**TO:** Planning and Zoning Commission  
**FROM:** Jaydevsinh Atodaria (JD), City Planner I  
Matthew Tolan, Civil Engineer II  
**DATE:** January 19, 2023  
**SUBJECT:** PC-2 District Site Plan Review – 930 Viking Road, outbuilding #2

**REQUEST:** Request to approve a PC-2 Planned Commercial District Site Plan for a new 6,050 square foot retail building.

**PC-2 Site Plan Review  
for Outbuilding #2, 930 Viking Road  
(SP22-019)**

924 Viking Rd - Revised SWPPP Plan

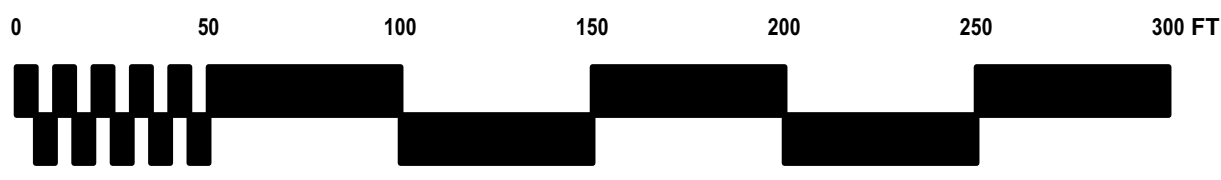
- 9) **Storm Water Management:** There are two previously installed underground storm water collection areas located under the parking lot in front of Outbuilding #1 and Outbuilding #3. These detention basins release the water into the storm sewer located along Viking Road. Also, there is a storm water detention area located to the southwest of the gymnasium building. Water from around the gymnasium building and areas south of the gymnasium building will flow to this detention pond. This overall storm water management plan was reviewed and approved by the Engineering Division during the site plan review of the gymnasium building in 2016. An individual SWPPP application and permit will be required for this building. **Staff notes that there have been issues with compliance, so staff will be monitoring to ensure that all SWPPP controls are installed and maintained properly (see technical comments below).**

The City Engineering Division has had comments regarding their Storm Water Pollution Prevention Plan (SWPPP) for the site. A number of deficiencies were noted by City staff during several past site visits; however, those items have been addressed by the developer. The developer and contractor for the site will need to address any changes that occur as construction continues on the site with continued maintenance, weekly inspections, seeding during appropriate times, and use of SWPPP approved stabilization techniques. The City is requiring that the developer obtain an individual SWPPP permit for each of the remaining buildings on the site prior to construction to help maintain control of the site during the duration of the remaining construction on the site.

**As this is the last outbuilding to be built on the site, the City Engineering Division recommends that all site final grading and stabilization take place prior to the final occupancy of said outbuilding. All improvements including the sidewalk along W. Viking Road, landscaping improvements, trash enclosure and the parking lot south of the Gymnasium will be required to be completed to fulfill City Code requirements for the site. All improvements will need to be made and in working order as the site will be considered fully developed upon the completion of the last outbuilding.**

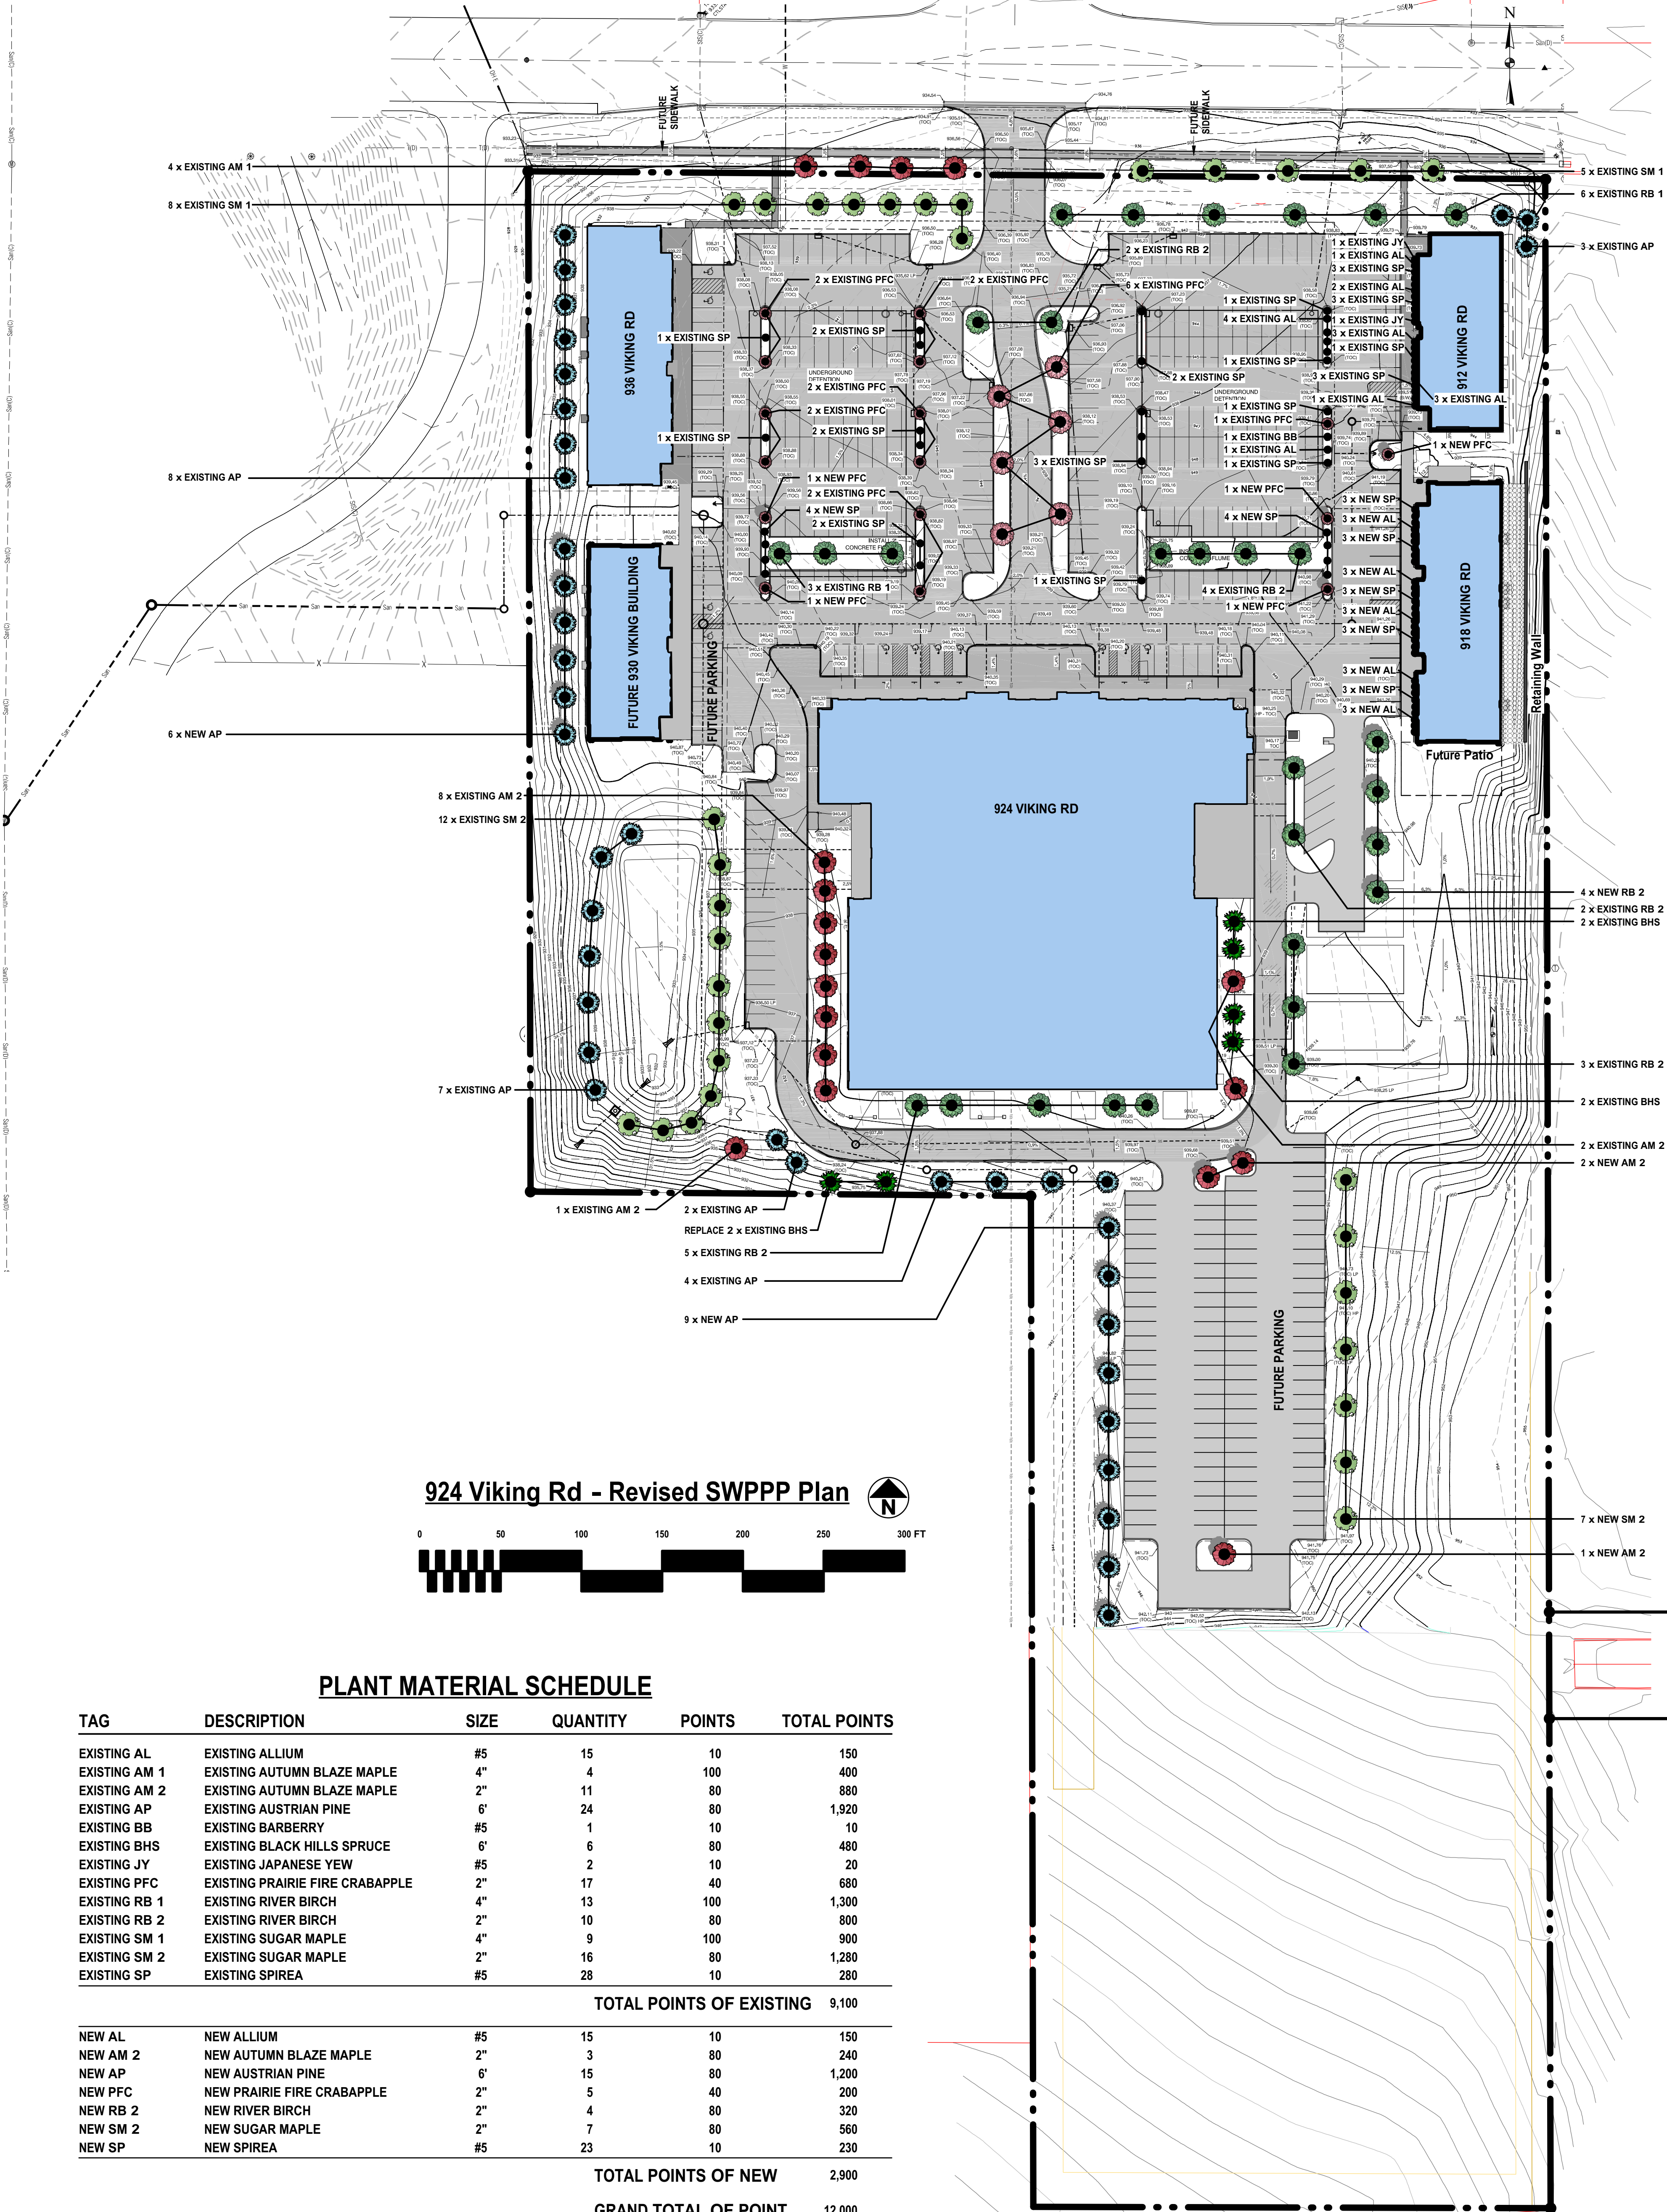
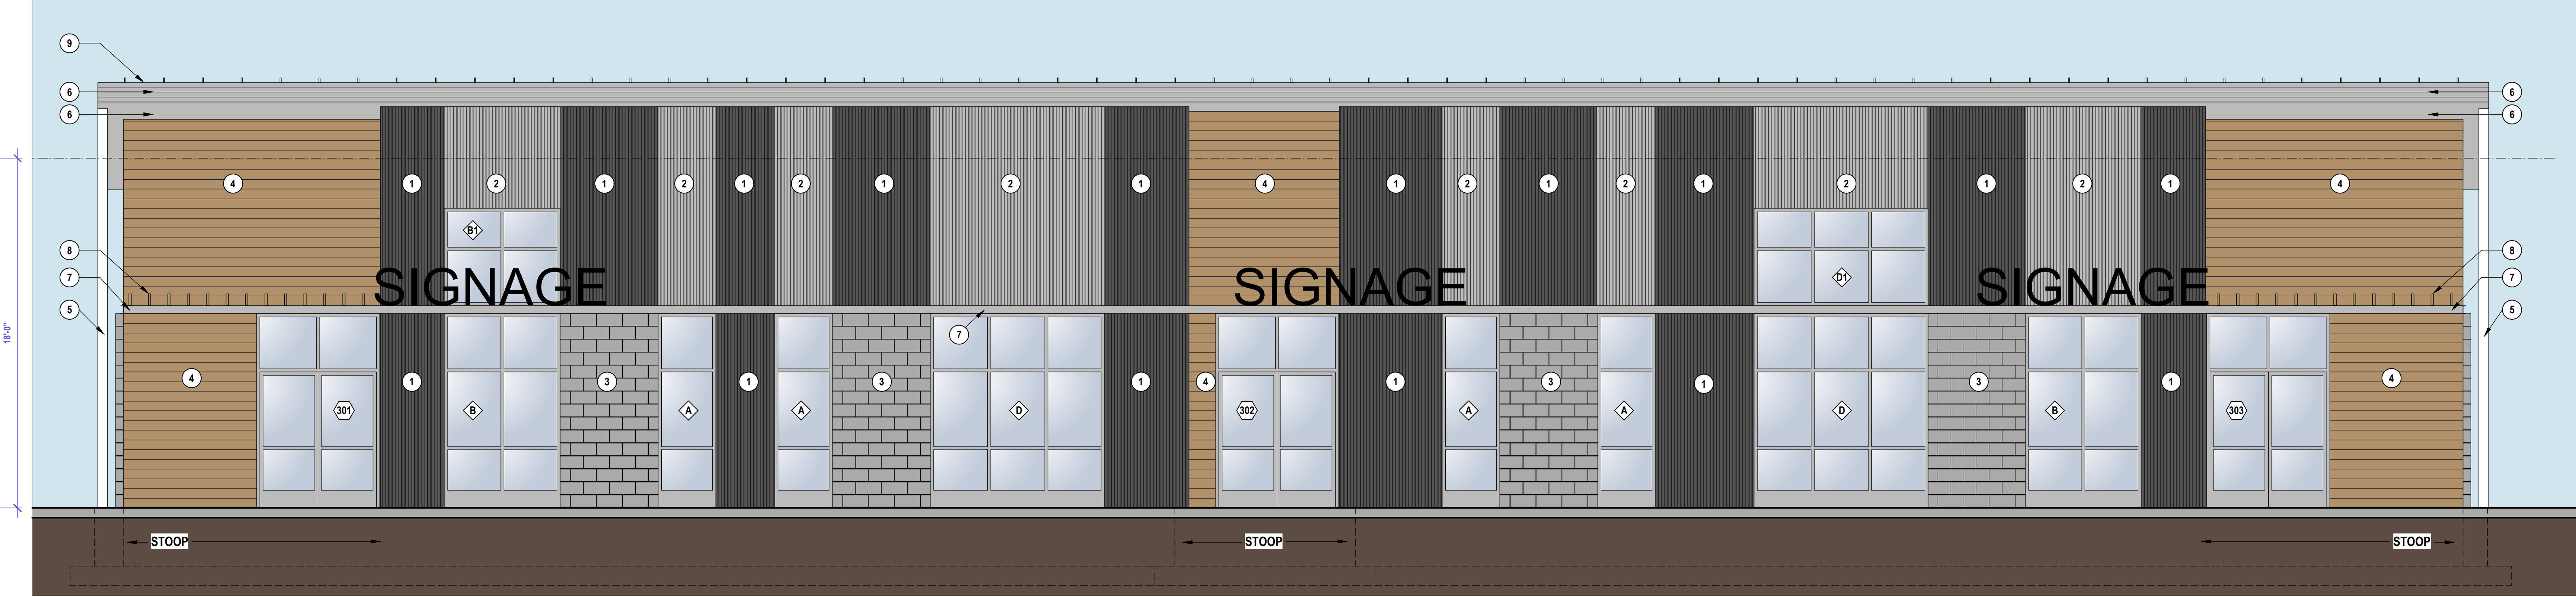
In addition to basic site landscaping points, there is a requirement of 0.75 points per linear foot of street frontage. The overall site has a street frontage of 630 feet. So, based on it the site is required to have **473 points** ( $0.75 \times 630 \text{ ft} = 473$ ). A total of 12,443 points is required. The landscaping plan is 443 points short of the requirement. **Staff recommends adding parking lot screening shrubs along the Viking Road street frontage, as required in the parking chapter of the zoning ordinance to satisfy the additional required points.**

Overall, the applicant is providing landscaping equivalent to 12,000 landscaping points, of which 9,100 points of landscaping has already been planted. The site will have well-distributed landscaping areas, once all landscaping is complete. As noted above, staff recommends additional screening shrubs along Viking Road to satisfy the remaining 443 landscaping points required. Staff notes that the landscaping work should be completed prior to obtaining the occupancy permit for the proposed outbuilding #2 (930 Viking Rd.) and outbuilding #4 (918 Viking Rd. currently under construction). **Landscape Plan is acceptable provided additional screening shrubs are added as noted above.**

Sheet Name  
ELEVATIONS

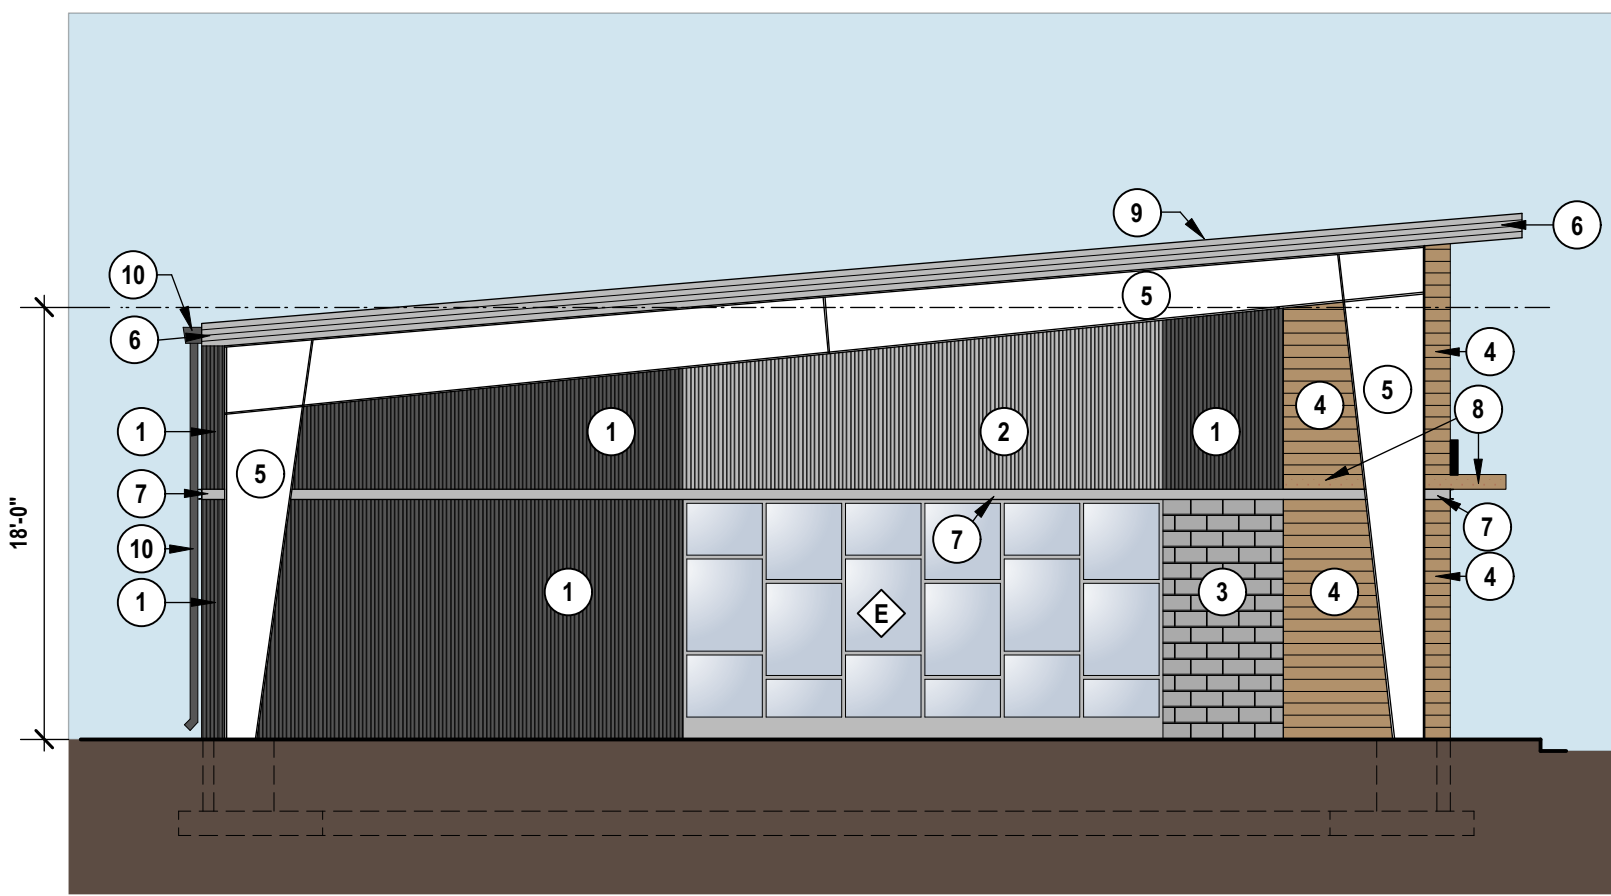
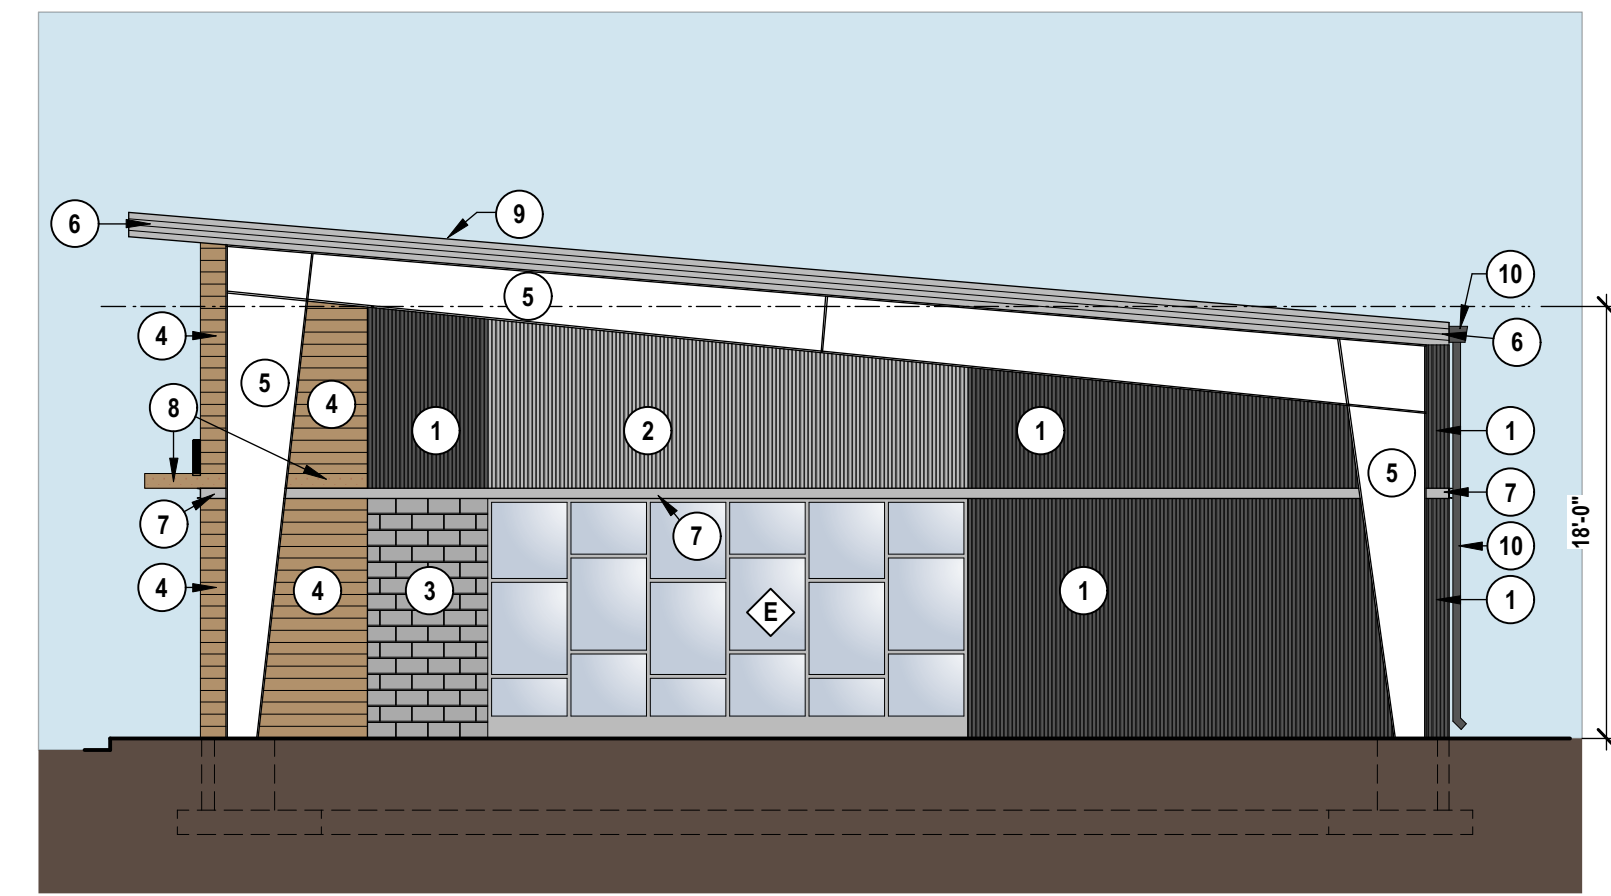
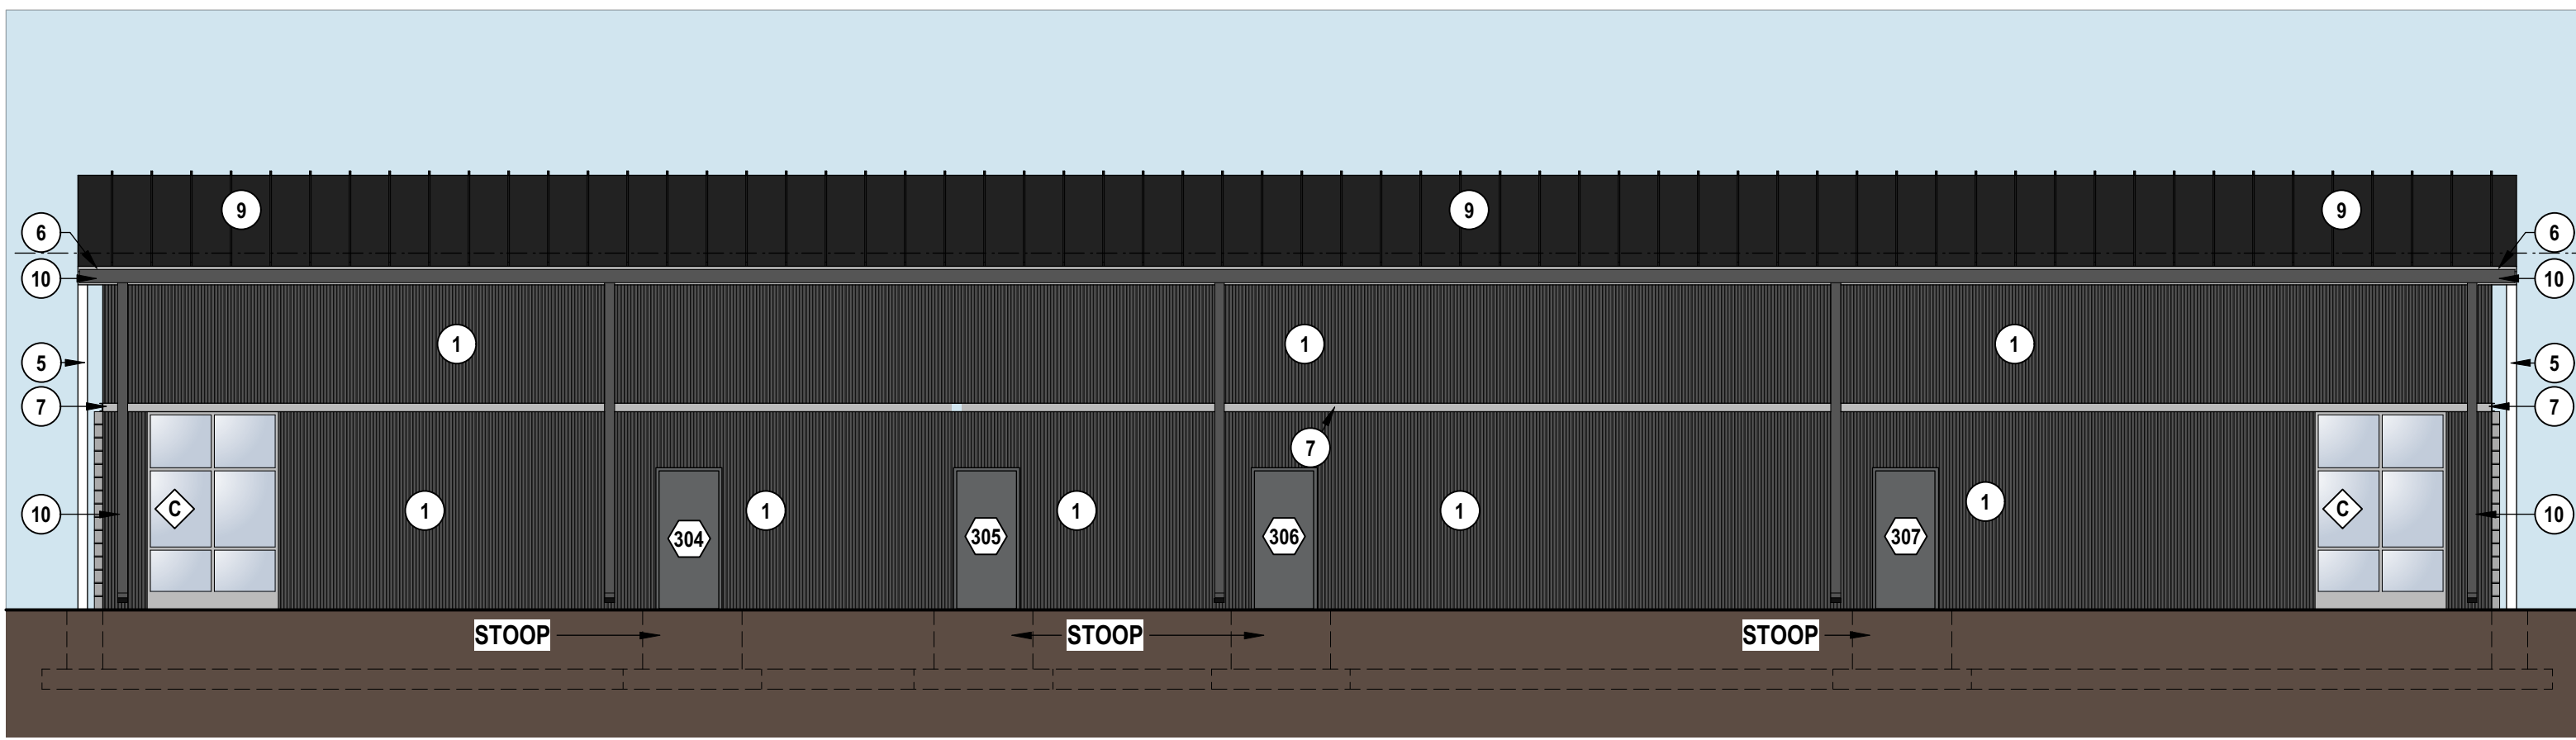
- 7) **Building Design:** The proposed building will be constructed with a mixture of rock-faced block (gray), Cumaru wood shiplap siding, glass windows and doors, and two tones of corrugated metal paneling (silver and charcoal). Wall signage will also be located above each doorway. This building design is the same as Outbuilding #1, #3 and #4, which were previously approved. **Overall Building Design is acceptable.**
